### ADDENDUM # 2

Proposal No.: **2025-01 CONL**

New London Board of Education Boiler Replacement (2)

**Bidders Notes:** This addendum is issued to provide all potential bidders with answers to questions submitted.

### COPPER-FIN® GAS FIRED WATER HEATERS

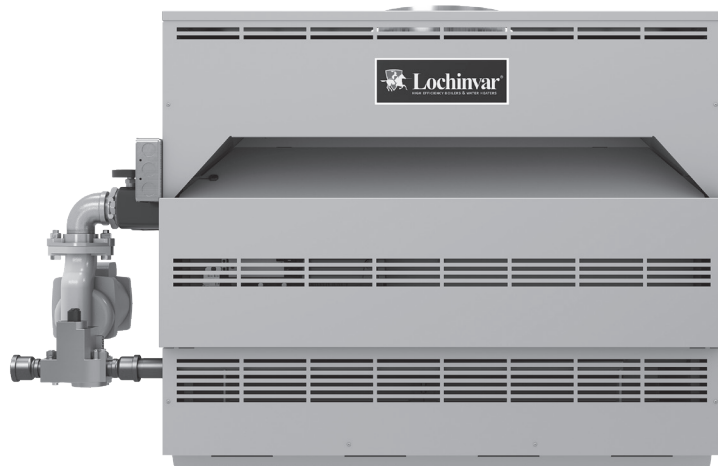
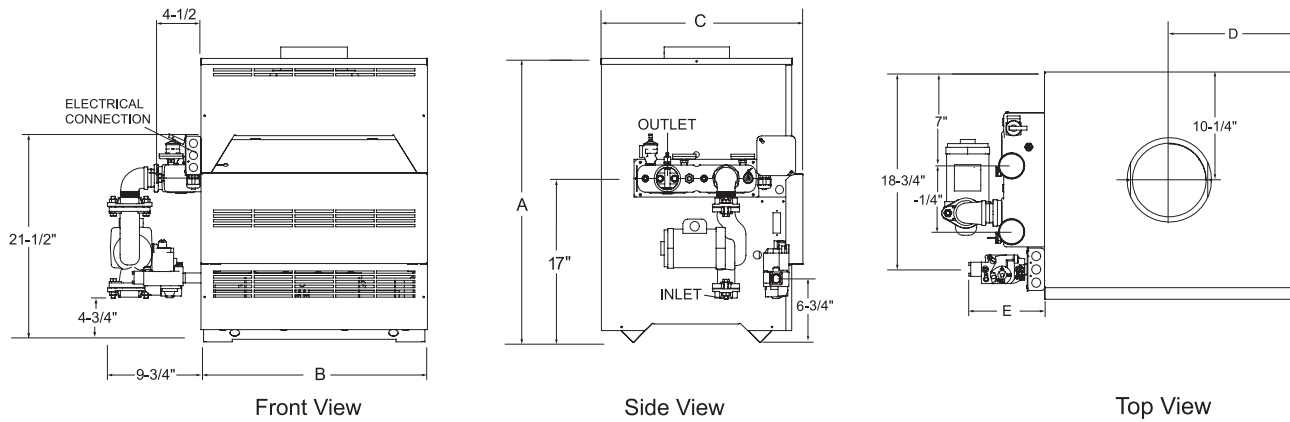
5. The existing water heater at Jennings is non-condensing and aging. It would not be able to be tied back into new Centrotherm breeching.?? Please provide a directive for water heater.  
*A5. I have attached spec sheets to this addendum on the existing hot water boiler and new boiler to be installed at Jennings. Both attachments are labeled appropriately.*
